**METROPOLITAN GOVERNMENT OF NASHVILLE AND DAVIDSON COUNTY**

**STAFF RECOMMENDATION**  
**210 South Tenth Street**  
**August 19, 2015**

**Application:** New construction-infill  
**District:** Edgefield Historic Preservation Zoning Overlay  
**Council District:** 06  
**Map and Parcel Number:** 08216016600  
**Applicant:** Mitch Hodge  
**Project Lead:** Robin Zeigler, robin.zeigler@nashville.gov

ELEVATIONS

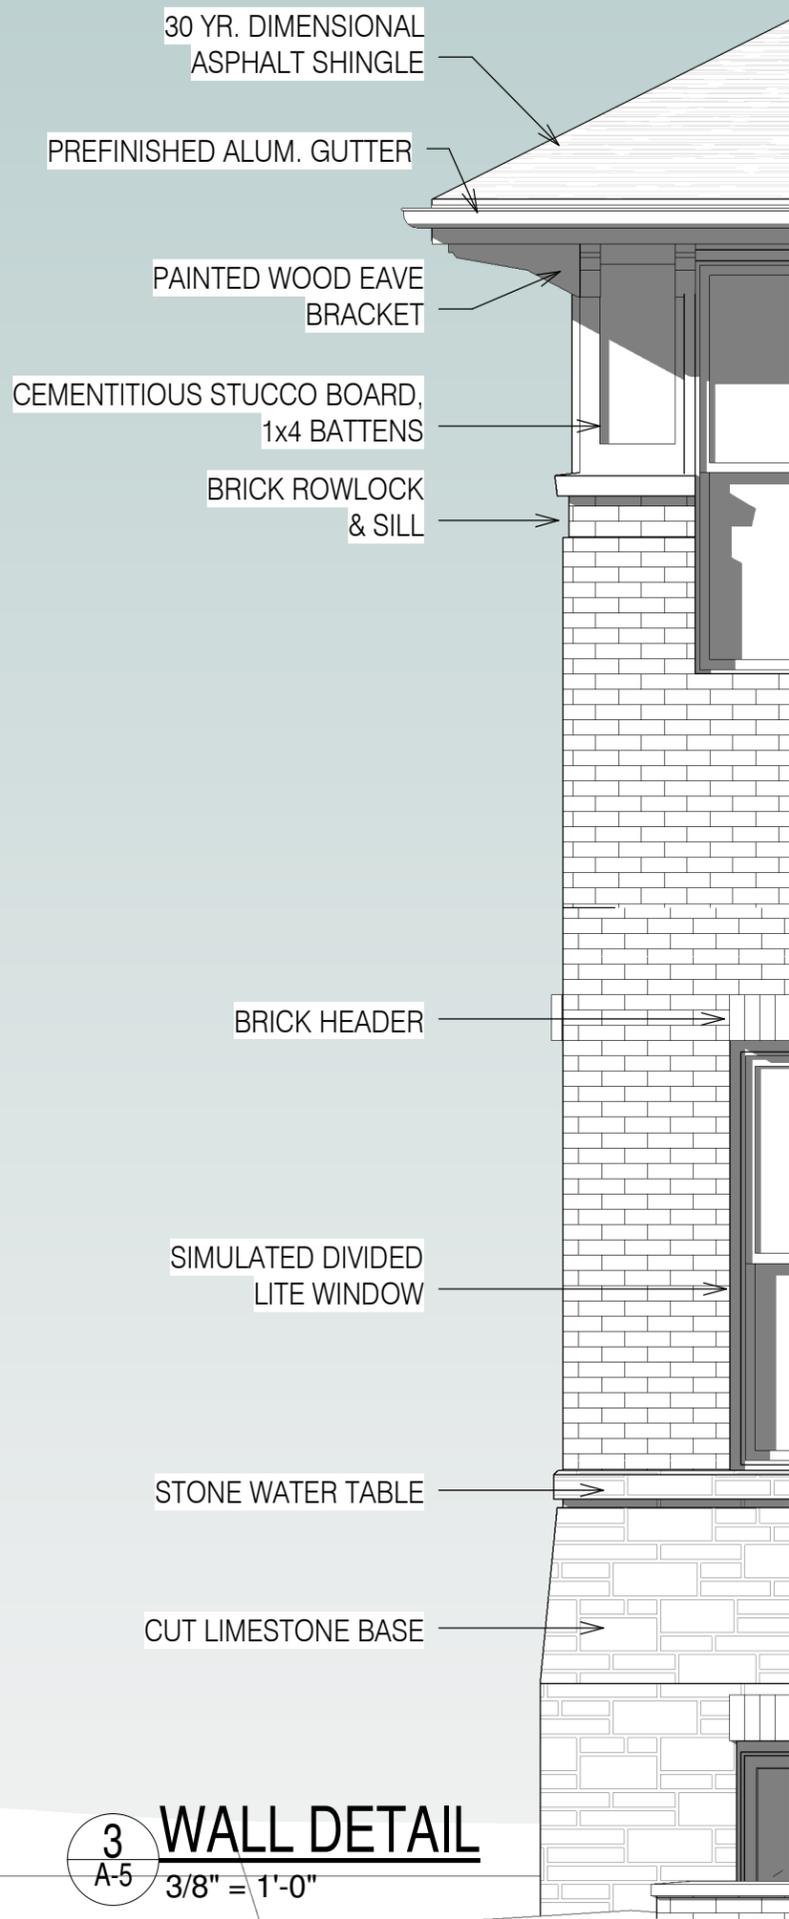
Roof Shape: There are slight changes from the approved preliminary plan for the roof shapes. Units 4 and 5 now have a side-gable roof on the South 10<sup>th</sup> Street side and unit 3 has a side-gable roof form for a portion of the building that faces Russell Street, rather than flat roofs as originally planned. Either form is appropriate; however, the side-gable form helps to minimize the massing and so is considered an improvement.

Orientation: All units have primary entrances facing the street. The two-single family homes facing Russell Street have partial-with porches facing Russell Street. The porches are six feet deep, which has been a requirement of past projects. Staff recommends a condition that the porch posts have caps. Details of the porches are not evident with this level of drawing and staff recommends a condition that more detailed drawings be submitted before the permit is issued.

Rhythm of Spacing: The proposal meets all the height requirements of the preliminary plan, with the exception of the rear portion of unit 1. For the preliminary review, Staff recommended and the Commission agreed, that the rear portion should be no more than one and one-half stories to mitigate the additional massing as seen from the street and the impact the additional massing would have on the lot to the right. The rear portion was originally planned as a garage on the ground floor and living space on the second floor. Because of grade constraints, lowering the height of the rear portion enough to meet the one and one-half requirement would mean moving the garage entrance to the right side of the primary massing of the house. The entrance off the side alley will be awkward and

the garage doors highly visible on Russell Street. The current proposal is the same height as the preliminary proposal; however, the roof form has been changed from a flat roof to a hipped roof which helps to minimize its massing. In addition, this portion of the house sits back thirty feet (30') from the front wall of the house. Staff recommends approval of the proposal with the full two-stories, finding that scenario to have less of an impact on the neighborhood than a side garage in the main massing of the house and because alterations have been made to its roof form, minimizing its massing.

Proportion and Rhythm of Openings: All windows are twice as tall as they are wide and are spaced in a manner that is consistent with the historic rhythm of openings found in the district. Paired windows have a 4"-6" mullion between them and the design of the windows is one-over-one, double hung. The project meets section II.B.2.f of the design guidelines.

Materials, Texture, Details, and Material Color: The foundation will be cut limestone, the siding brick and cement-fiber board-and-batten, and the roof will be asphalt shingle. The color of the roof was not indicated. Staff recommends approval of materials with the conditions that staff approve the color of the roofing, trim and porch materials, and the final make and model of windows and doors. With these conditions, the project meets section II.B.2.g of the design guidelines.

Staff recommends approval with the conditions that:

- Staff approve final materials such as masonry, windows and doors, trim and porch materials and roof color;
- New drawings be submitted prior to permitting that show a greater level of design detail; and,
- HVAC be located on the rear façade, on a side façade beyond the midpoint of the house or, in some cases, on the roof.
